Product Change Notification: P-15-012167

PCN Date: 21-OCT-15

General Product Description:
MiniSAS HD, 1x2 receptacle

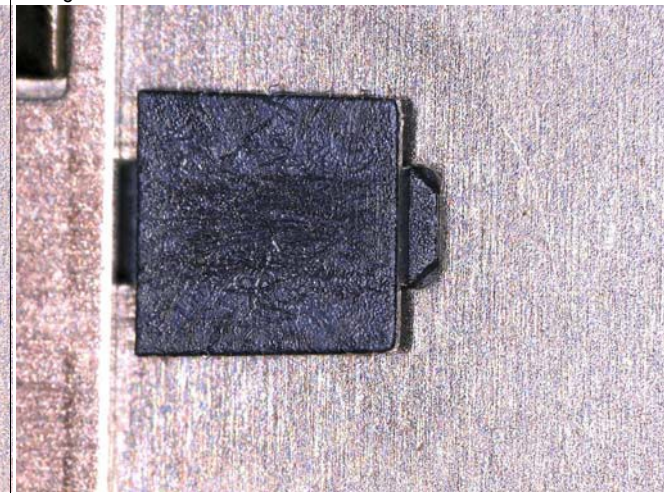
Add the plastic material to the housing to go into the existing hole on the sides of the cage to keep the connector from shifting in the cage.

Product improvement. Product improvement, the improvement can prevent the connector shifting in cage. And the PCN is also a supplement to the PCN (E-15-013808). For housing, we have improved, we can produce the products with new housing now, so I only make the date (Estimated First Date To Ship Changed Parts) of Nov 21, 2015.
